Mound-George IV Bridge-Lauriston Place bus stop audit report

1. Introduction

iv. Outbound / George IV Bridge at Victoria St / missing (suspended) stop

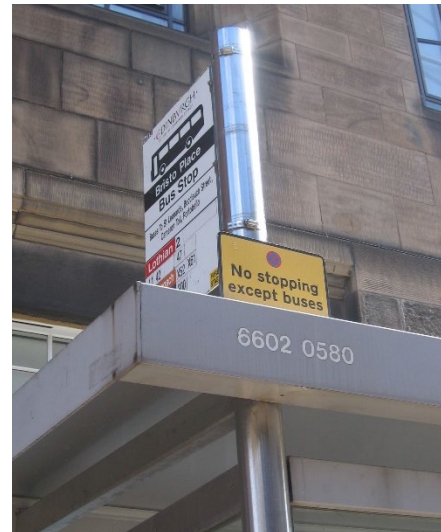
Suspended stop in middle distance
